BRADLEY FAIR 2ND ADDITION TO WICHITA, SEDGWICK COUNTY, KANSAS

RE: S/D 95-78 - Revision to Final Plat of the BRADLEY FAIR 2ND ADDITION

RE: S/D 95-78 - Final Plat of the BRADLEY FAIR 2ND ADDITION

CASE NUMBER: S/D 95-78 BRADLEY FAIR 2ND ADDITION

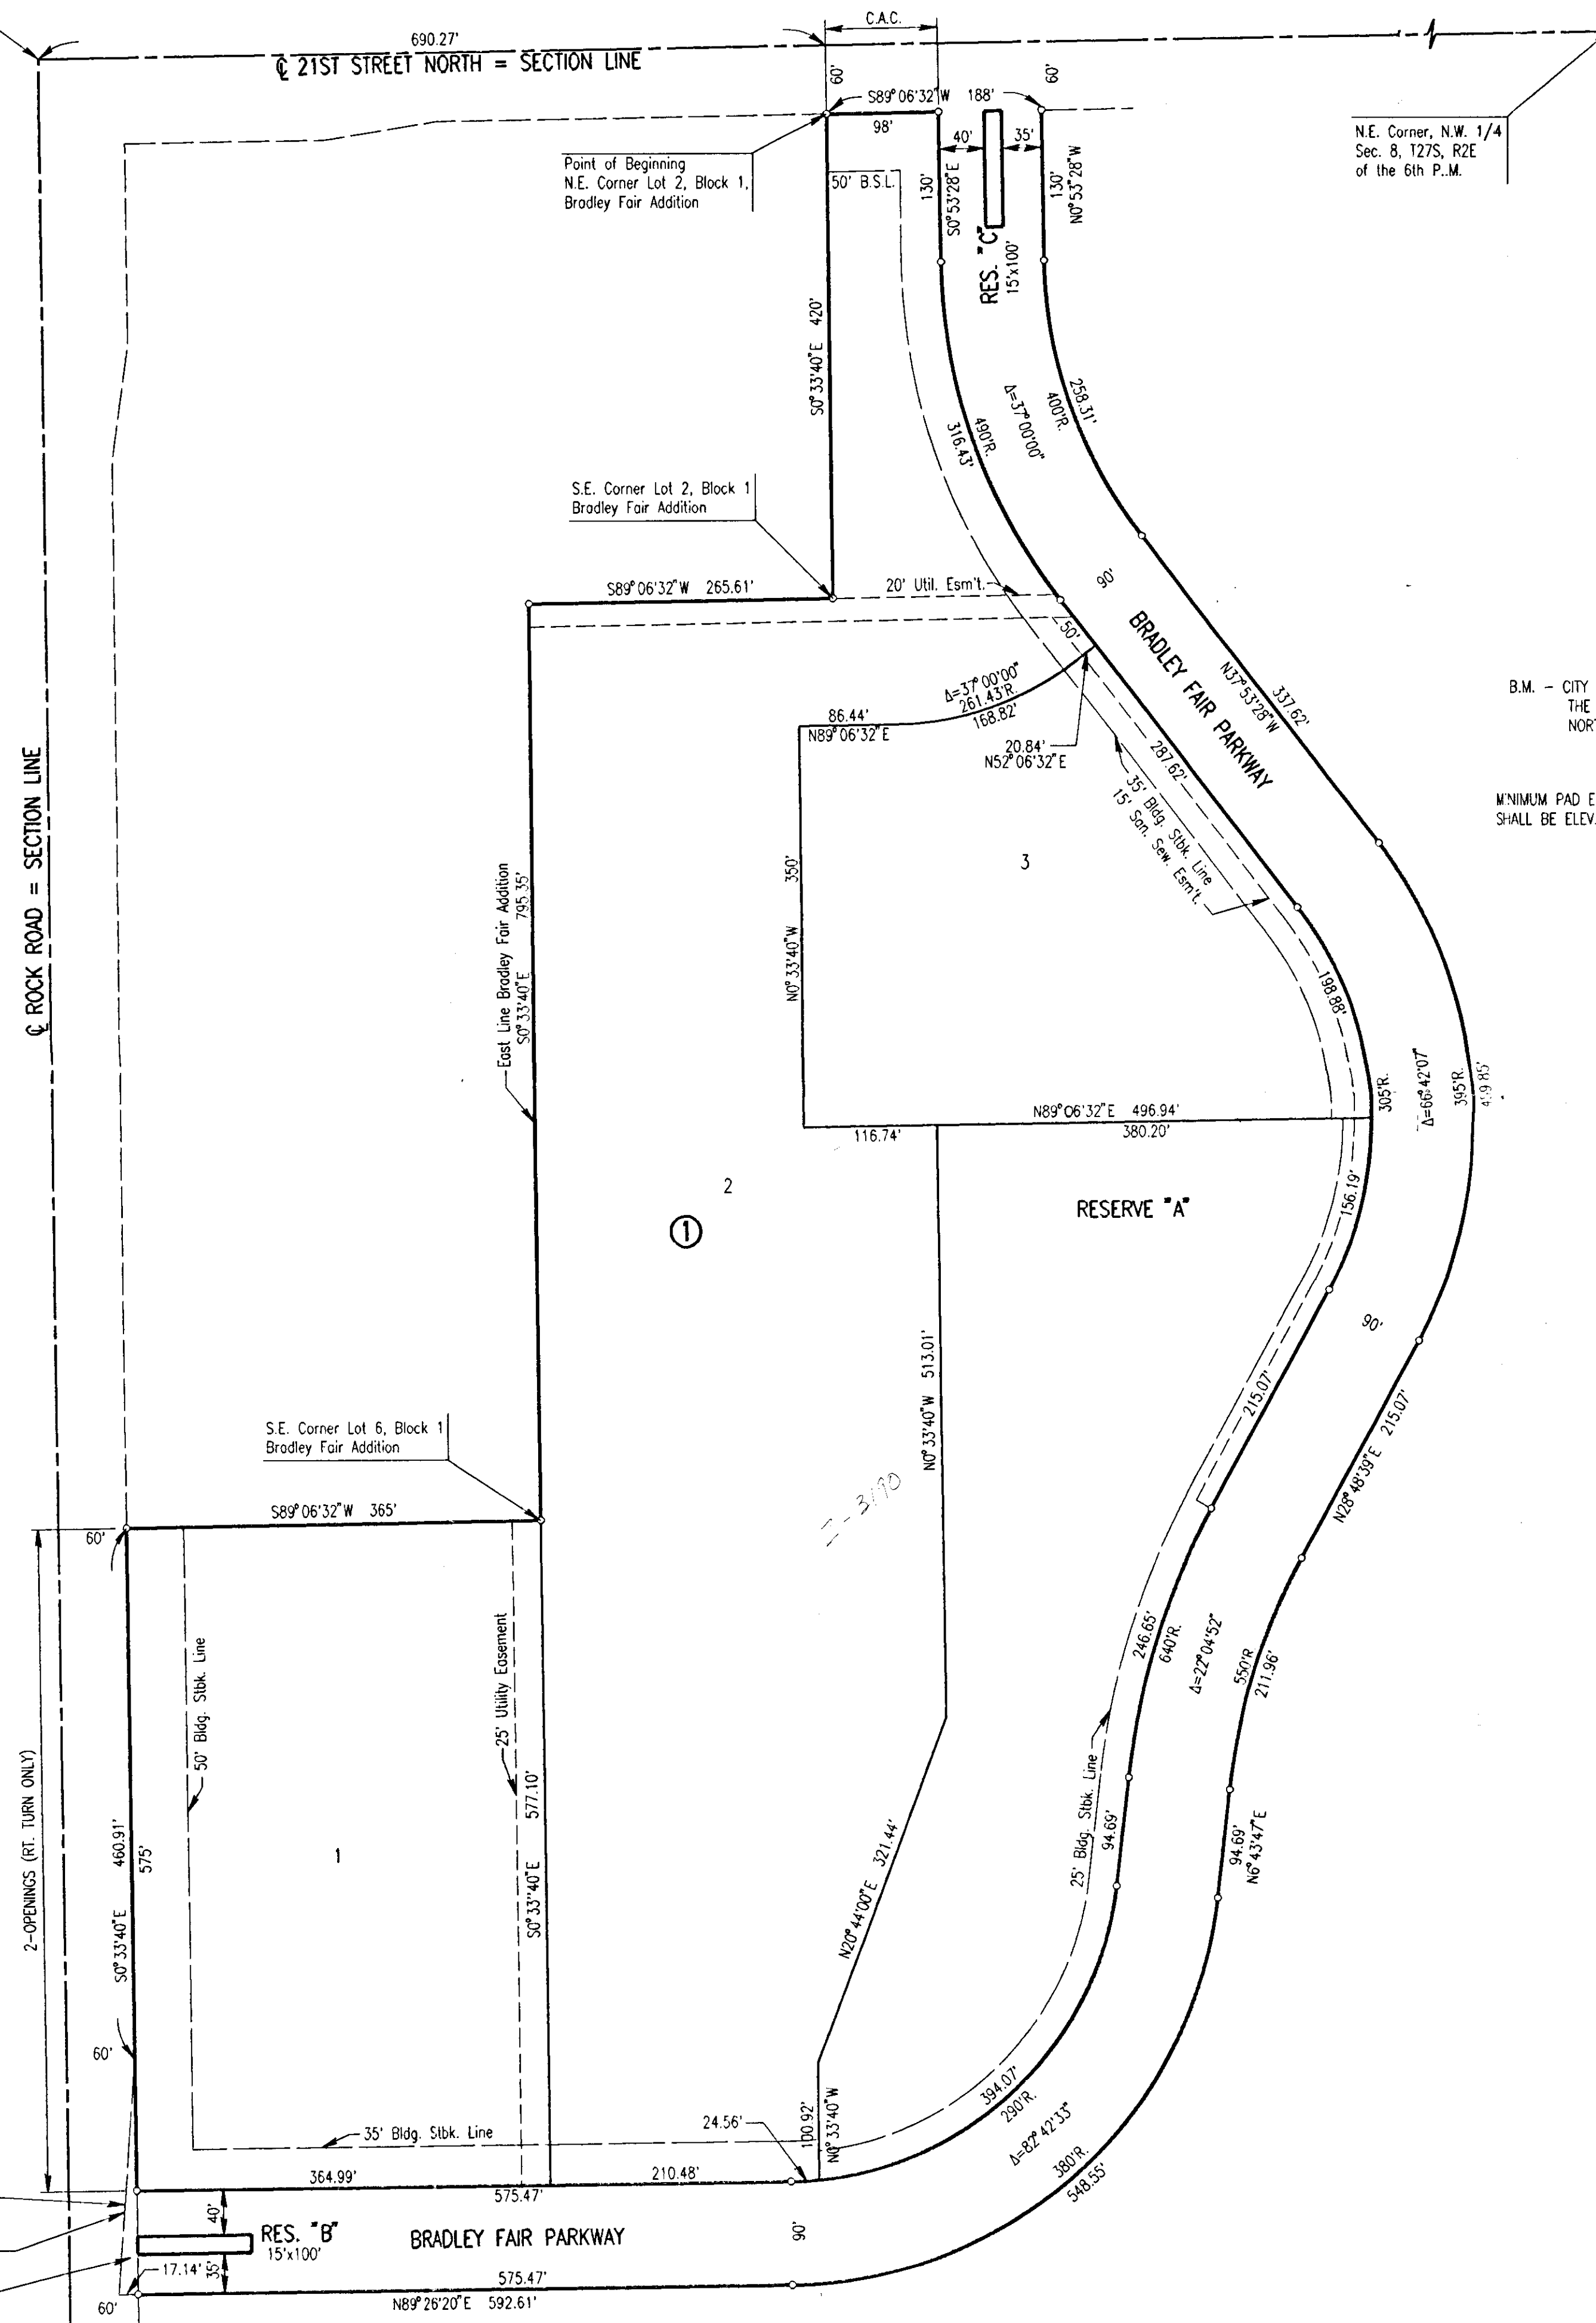
- ☒ A. The applicant is advised that Lot 2 will be composed of two parcels from DP-191. While most of this lot is shown in the CUP as involving a Parcel 8, the portion of Lot 2 between 21st Street and Lot 3 is a part of Parcel 5. Parcel 5, itself, will now be split between two lots, of two separate plats. Such situations provide a "potential" problem in interpreting the allocation of uses, square footages, number of buildings, setbacks, etc. to be allocated to the actual platted lots relative to what has been associated with the CUP's parcels.

- ☒ B. The applicant shall guarantee the extension of sanitary sewer to serve the lots being platted. The applicant shall also guarantee any needed sanitary sewer relocations made necessary by this plat. Also, as requested by City Engineering, the applicant shall submit for recording, temporary easements for the sewer lines being relocated.

- ☒ C. The applicant shall guarantee the extension of City water to serve the lots being platted.
- ☒ D. The applicant shall guarantee the paving of the proposed interior streets. A cross-section map showing the paving of Bradley Fair Parkway should be submitted to City Engineering. This street is being platted with a right-of-way greater than that stated as necessary by the Subdivision Regulations. This guarantee shall also provide for sidewalk along both sides of this street. Engineering is requiring a map showing the cross-section paving of Bradley Fair Parkway.

- ☒ E. As indicated by CUP, DP-191, the following improvements shall be guaranteed:
 - 1. The construction of a raised median in Rock Road from Parcel 7 south, to form left-

turn storage lanes for Rock Road Court, Bradley Fair Parkway, and the entrance into Sundance Apartments. Said median shall be designed in conformance with the requirements of the City Traffic Engineer and applicant. A plan showing medians, left-turn lanes, and accel/decel lanes should be submitted to City Traffic Engineer.

2. The construction of a left-turn lane to serve Tara and the main entrance into Parcel 2 (Lot 2, Block 1 of the preliminary plat) as determined necessary by the City Traffic Engineer. Said turn lanes shall be designed in conformance with the requirements of the City Traffic Engineer and applicant.
3. The construction of a deceleration lane to serve all parcel (lot) openings on 21st Street North and Rock Road as determined necessary by the City Traffic Engineer. These decel lanes shall be designed in conformance with the requirements of the City Traffic Engineer.
4. Traffic signalization at Rock Road and Bradley Fair Parkway shall be provided by the developer. This improvement will be held until such time as conditions warrant the improvement.

F. The applicant shall guarantee any drainage improvements required by the platting of this property.

G. The applicant shall guarantee construction of the storm sewers required by this plat.

I. Provisions shall be made for ownership and maintenance of the proposed reserves. The applicant shall either form a lot owners' association prior to recording the plat or shall submit a covenant stating when the association will be formed, when the reserves will be deeded to the association and who is to own and maintain the reserves prior to the association taking over those responsibilities.

J. For those reserves being platted for drainage purposes, the required covenant which provides for ownership and maintenance of the reserves shall grant, to the City, the authority to maintain the drainage reserves in the event the owner(s) fail to do so. The covenant shall provide for the cost of such maintenance to be charged back to the owner(s) by a method similar to special assessments.

- M. The applicant is reminded that a sidewalk plan as noted in the CUP will be required at the time of site development. This in addition to those sidewalks required along Bradley Fair Parkway.

At the March 28, 1996 meeting of the Metropolitan Area Planning Commission (MAPC), your request to revise the above referenced plat was considered. The MAPC agreed that the Reserve area as originally platted within Bradley Fair Parkway's right-of-way could be revised as requested and shown on your revised plat. Except as necessary to reflect the above change, all conditions of approval as noted in the letter of January 18, 1996 are still in effect.

3/25/96 - see revised copy
of the final plat - MHA, IC
approved & elimination of
median / Reserve within Bradley
Fair Parkway.
